SERVICE BULLETIN

MITSUBISHI MOTORS

PURPOSE : CORRECTION	ISSUE NO. : MSB-15EM00_54_90-501	DATE : 2015-07-09
SUBJECT : Error in writings and omissions about the traction battery.		<DESTINATION/MODEL> (As per attached sheet 1) <M/Y> 15-16
GROUP : Gr:00(General)/Gr.54(Chassis electrical)/Gr.90(Circuit diagram)		i-MiEV(HA3W)

<New>
From attached sheet 4 (3/9)
<Old>

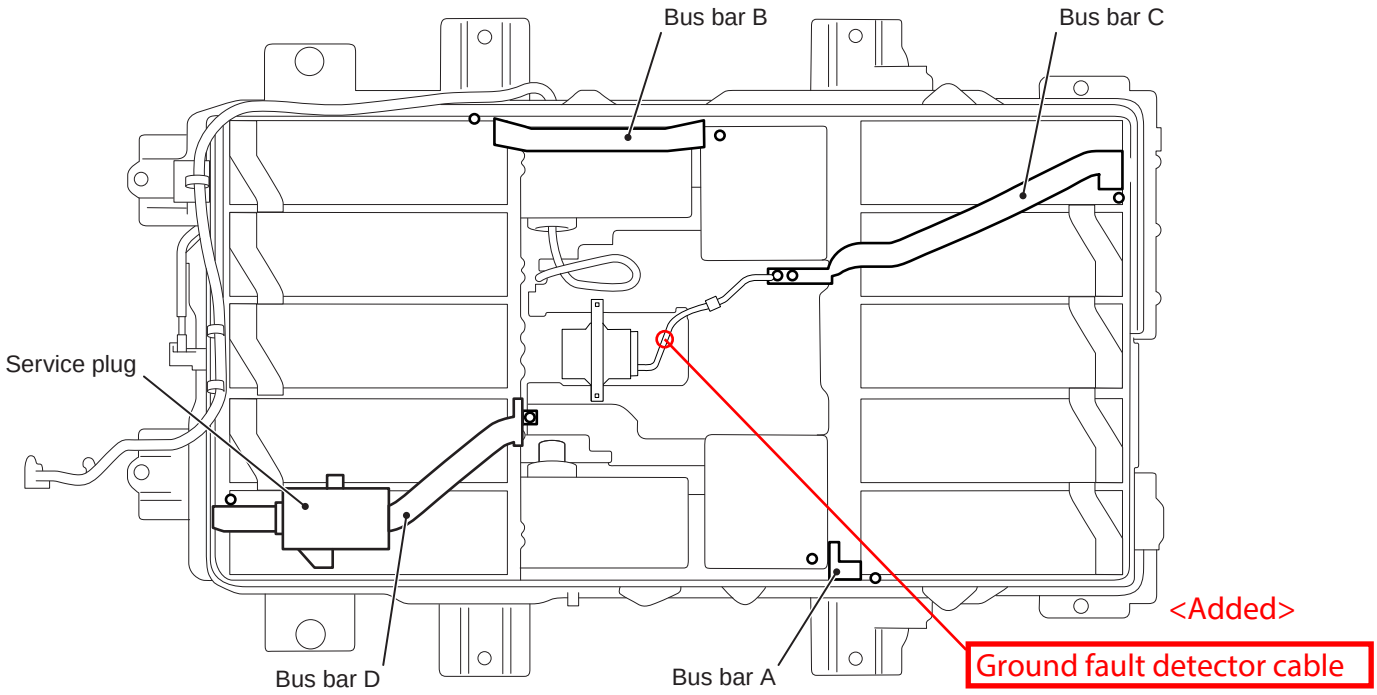
STEP 6. Check the wiring harness between H-19 BMU connector (terminal No.3, 26) and C-21 traction battery connector (terminal No.2, 13)
Check signal line for open or short circuit.

STEP 7. Check the cable between BMU connector and bus bar
Check line for open or short circuit.

Q: Is the check result normal?
YES : Go to Step 8.
NO : Repair the cable (Refer to P.54Dc-164).

STEP 8. M.U.T.-III diagnosis code.

Q: Is the diagnosis code set?
YES : Replace the BMU (Refer to P.54Dc-149).
NO : Check end.

<Added>

Traction battery module replacement

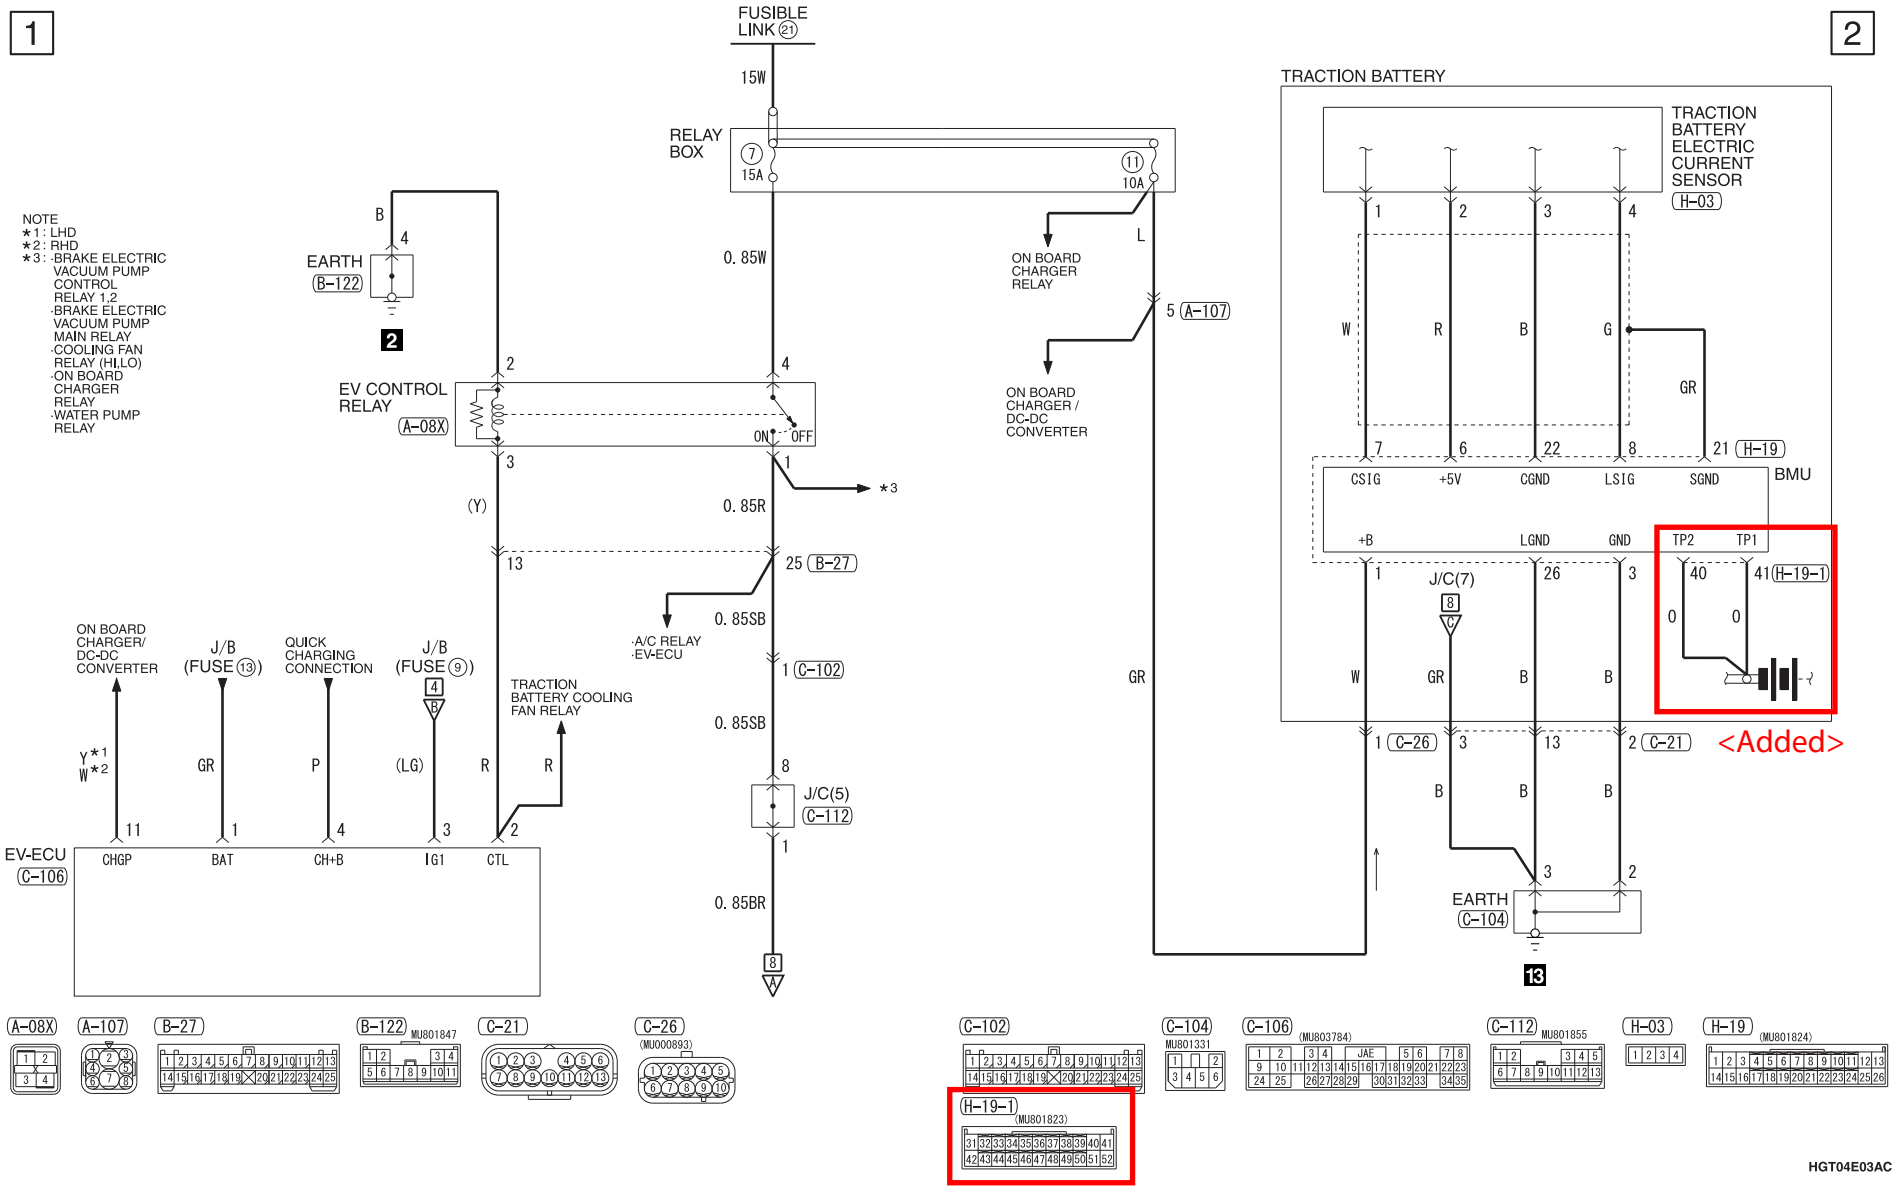
1. Remove the traction battery from the vehicle, and remove a defective module (Refer to).
2. Install the special tool (MB992920 or MB992921) in place of the removed module.
3. Use the M.U.T.-III to select and execute "CMU support forced release" on the BMU special function menu. Write the CMU ID of the removed module into the BMU.
4. Use the M.U.T.-III to select and execute the BMU special function menu "Battery auto capacity measured". Then obtain the replacement module in accordance with a measurement result (which is displayed on item No. 401 "Auto capa.measured result his.1"). If the voltage difference among the battery cells reach 25 mV or more with the traction battery fully charged, use special tool MB992913 to execute "Automatic Balance" (automatic charging) for the relevant battery module, which the voltage difference exists in.

6. Substitute special tool MB992920 or MB992921 with the replacement module.
7. Use the M.U.T.-III to select and execute "CMU ID numbering" on the BMU special function menu to number the CMUs for identification.
8. Use the M.U.T.-III to erase the diagnosis code. Then turn the electric motor switch to OFF position and wait for ten seconds.
9. Use the M.U.T.-III to select and execute "Battery auto capacity measured" on the BMU special function menu. Check that no diagnosis codes are set. (When not using the recommended tools, mount the traction battery assembly to the vehicle.)
10. Assemble the traction battery assembly, and perform the air leak check (Refer to). Then mount the battery to the vehicle.
11. Check the software version of the BMU and the CMU, and update if necessary.

<Correct>
To attached sheet 4 (7,8/9)
<Incorrect>

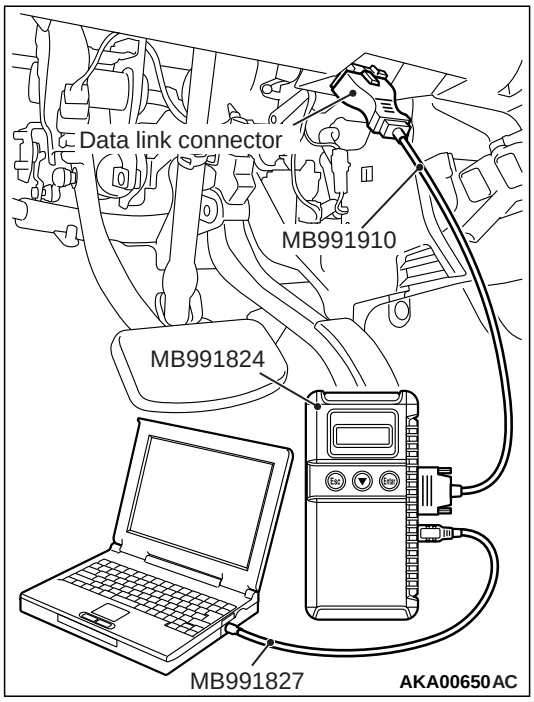
~~*NOTE: If replacing the BMU and the Main Drive Lithium-ion Battery at the same time, you do not have to do this procedure.*~~

<Deleted>
